Access Compliance Report

Public Rights-of-Way

(Curb Ramps)

Intersection ID: 29650	Main Street: MILLERS_CREEK_LN	Cross Street: SOUTHERN_GARDEN_LN	Location: NW
ADA ID: D49AB5FFCC87	Ramp Type: PerpDiag	Initial Pass/Fail: Fail	Overall Compliance: No
Severity Score: 31.25			
Codes/Mitigation Info/Possible Solution		Field Measurements/Component Compliance

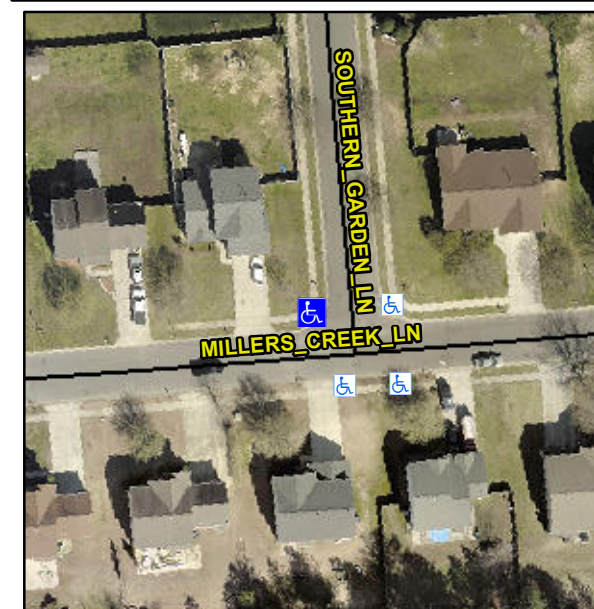
Not Found, R304.5.1, R304.2.2, R304.5.3

Compliance	Description	Data	Compliance	Description	Data
N/A	Ramp Length (in)	59.0	No	Ramp Slope (%)	11.9
No	Ramp Width (in)	33.0	No	Ramp XSlope (%)	2.1
N/A	Flare Type LT	N/A	N/A	Flare Type RT	N/A
N/A	Flare Slope LT (%)	N/A	N/A	Flare Slope RT (%)	N/A
N/A	Flare Traversable LT?	N/A	N/A	Flare Traversable RT?	N/A
N/A	Landing Length (in)	N/A	N/A	DWS Provided?	N/A
N/A	Landing Width (in)	N/A	N/A	DWS Contrast?	N/A
N/A	Landing Slope (%)	N/A	N/A	DWS Length (in)	N/A
N/A	Landing X Slope (%)	N/A	N/A	DWS Full Width?	N/A
N/A	Landing Curb? (Y/N)	N/A	N/A	DWS Offset (in)	N/A
N/A	Shared Landing?	N/A			
N/A	Gutter Ponding?	N/A	N/A	Gutter Slope (%)	N/A
N/A	Gutter Lip Ht (in)	N/A	N/A	Gutter X Slope (%)	N/A
N/A	Painted X Walk1?	No	N/A	Painted X Walk2?	No
	X Walk 1 Direction	To S		X Walk 2 Direction	To E
N/A	X Walk 1 Width (in)	N/A	N/A	X Walk 2 Width (in)	N/A
	X Walk 1 Slope (%)	1.0		X Walk 2 Slope (%)	4.1
	X Walk 1 X Slope (%)	6.4		X Walk 2 X Slope (%)	3.0

Remove & Replace Curb Ramp With Two New Directional Ramps or Equivalent.
